Existing Private Road Dedication Evaluation Spring Lake Hills Condominiums 3/21/18

Pursuant to the written request from SLHCA, and in compliance with Village policy for Existing Street Dedication Evaluations, staff has completed this report on the condition and potential challenges associated with acceptance of the Spring Lake Hills roads into the Village's network.

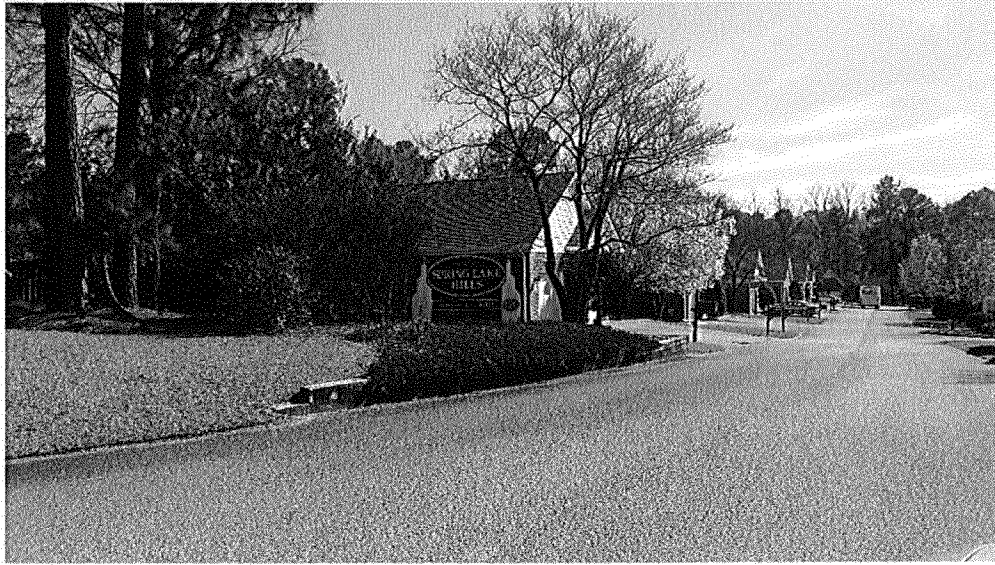
- One entrance provides access into the subdivision from Spring Lake Drive. A subdivision sign (Appendix B - Photograph 1) is located at the entrance on SLHCA property and there is no street sign at the entrance.

- Drainage facilities include two overgrown stormwater basins (Appendix B - Photographs 2 and 3). The majority of streets transfer stormwater to the road shoulder and eventually to the stormwater basins. Defined side ditches are not present and most of the flow appears to reach the basins by sheet flow or via a rock-lined ditch that starts at the edge of pavement and then progresses between two buildings to a basin (Appendix B – Photograph 4). A speed hump (Appendix B – Photograph 5) is used to direct the flow from the road surface to the rock-lined ditch. Along the cul-de-sac, there is a rock flume (Appendix B – Photograph 6) and two speed bumps that appear to be attempts to slow and direct stormwater flow (Appendix B – Photograph 7).

Photograph 8 – Timbers

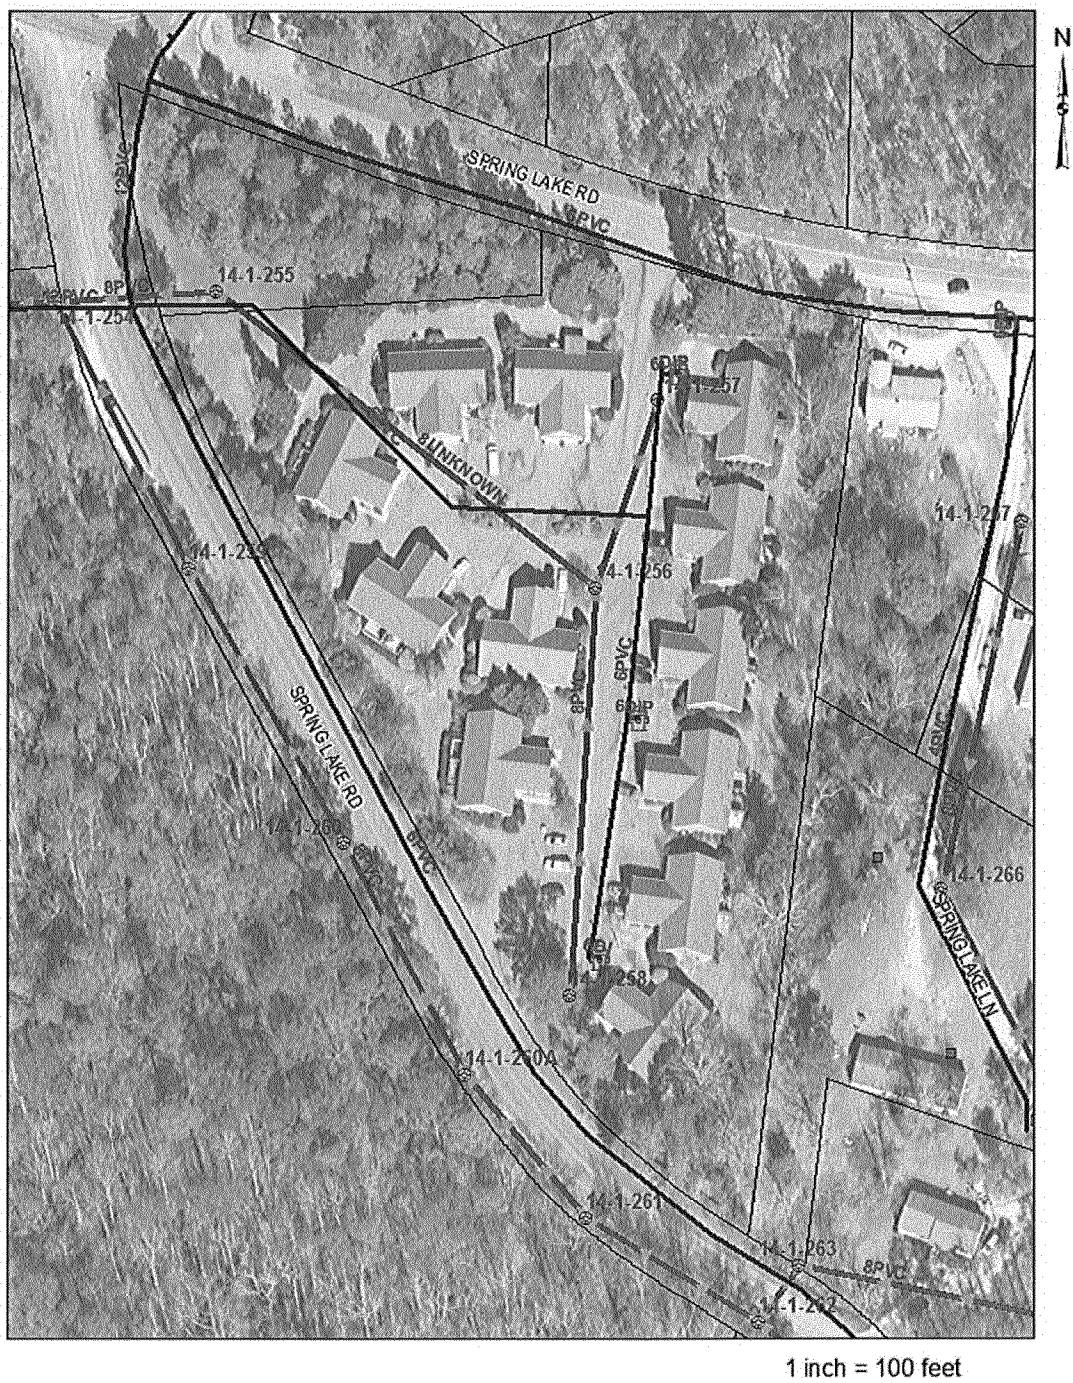
- Water mains and gravity sewer lines are owned and maintained by MCPU. Appendix C shows line and manhole locations. Existing fire hydrants (3) are periodically spaced along the road shoulder.
- The Village currently provides trash and recycling pickup services with individual carts assigned to units.
- Each condominium unit has its own mailbox and an asphalt driveway with garage.
- There's one landscape timbered wall adjacent to the pavement (Appendix B - Photograph 8).

- The landscape timbered wall could only remain if an encroachment agreement were granted.
